Service Bulletin

Bulletin No.: 24-NA-151
Date: March, 2025

Subject: Loose Roof Ditch Molding

Brand:	Model:	Model Year:		VIN:		Engine:	Transmission:
		from	to	from	to		
Chevrolet	Silverado EV (RST)	2024	2024				
	Silverado EV (WT)						
GMC	Sierra EV	2024	2024

6713545

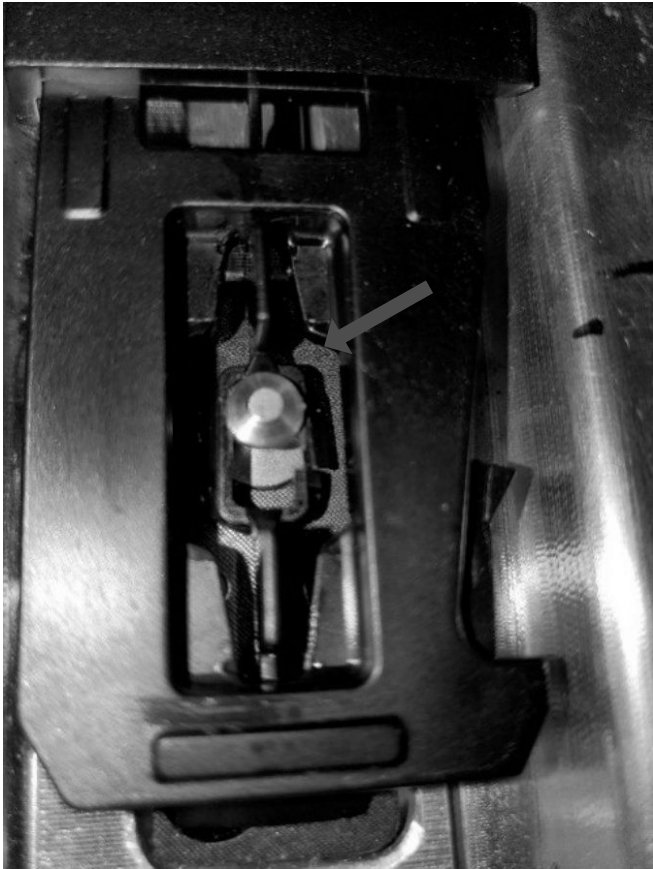
6. Then apply the adhesive to the front end **ONLY** of the roof ditch molding in a 5mm circle and immediately place in position. Secure that end to the roof with a small amount of pressure for 30 seconds. The adhesive dries quickly (Aprox. 20 seconds) so be sure to plan the placement and properly align it to the roof.

Note: It's best to install the front end first for the best appearance and below the windshield lace to prevent wind noise.

6788677

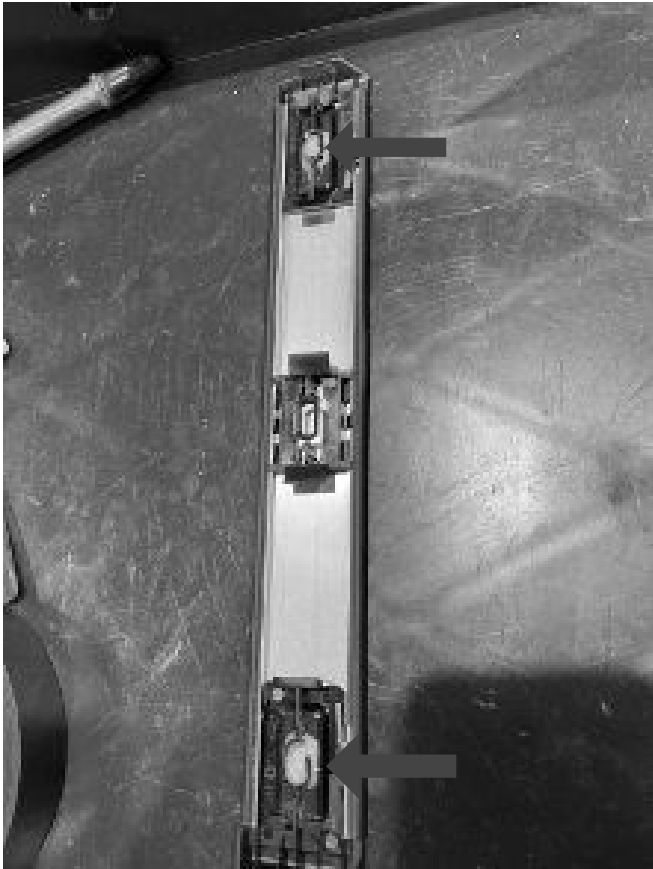
1. If a NEW roof ditch molding is installed and after replacement, the molding sits flush to the roof and all molding mounting clips to the body studs are tight and secure, then no further action is needed.
2. If the existing roof ditch molding that was removed does not show signs or visible exterior damage but does have fracturing of the mounting clips, then proceed with the outlined service procedure below.

6713553

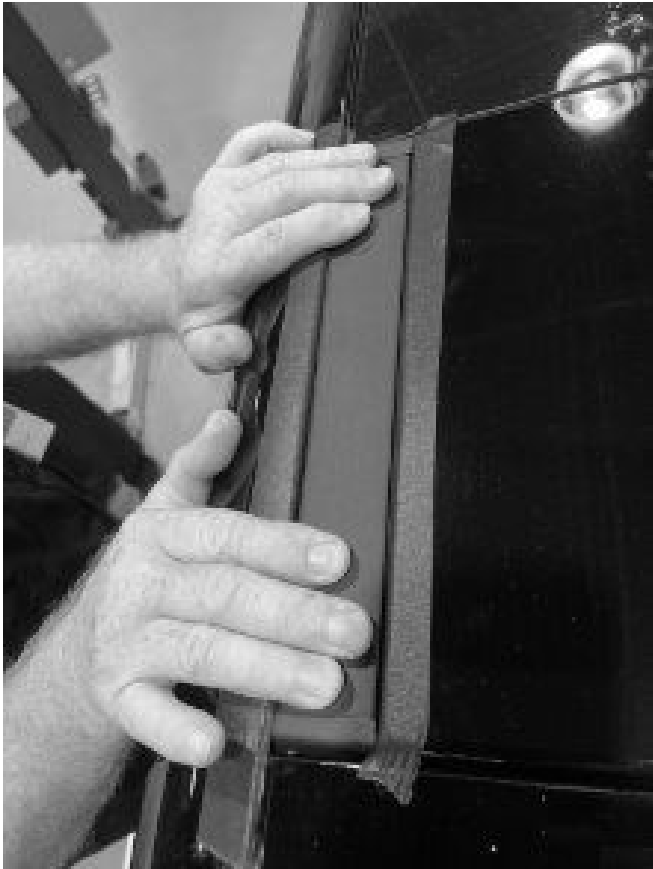
4. Using a trim tool, remove the roof ditch molding and place on a flat surface.
